MASTER DEVELOPMENT PLAN
for

CULEBRA CREEK II 792-A

Re: Culebra Creek II (Amendment)

MDP # 792-A

COLLECTOR
NOT TO SCALE

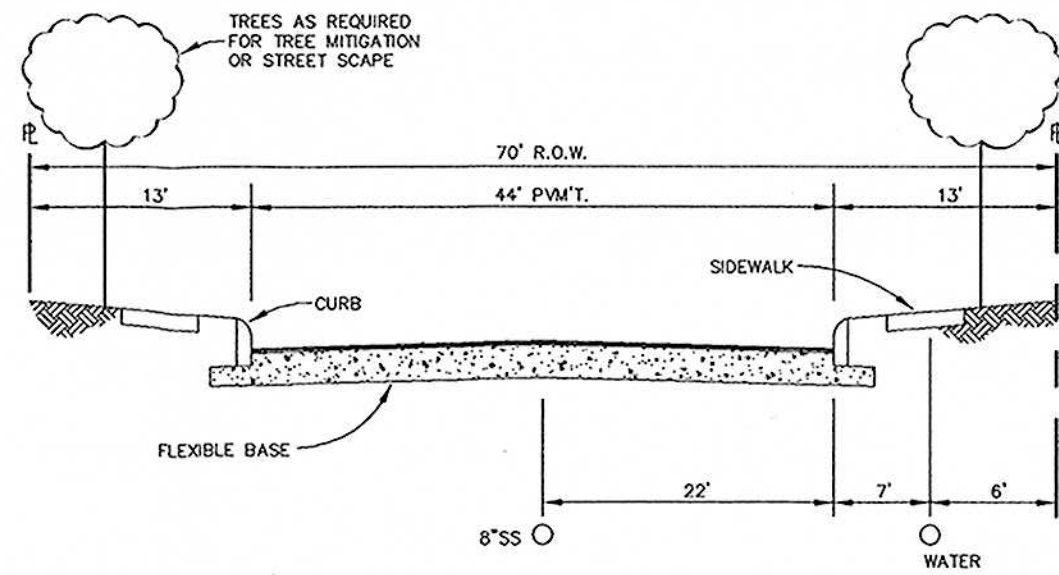
2. Construction of an internal collector street system approximately 3000-feet in length. Collector street design parameters consist of 70-feet of ROW and 44-feet of pavement (Table 506-3). The proposed collector street shall have no houses fronting (DUCK 35-515, (c), (4)).

The proposed Culebra Creek II Collector Street at build out will carry an estimated 10,000 Average Daily Trips (ADT). Any additional development connection to the proposed Culebra Creek II Collector Street will have to provide a secondary access by extending the Collector Street to Galm Road.
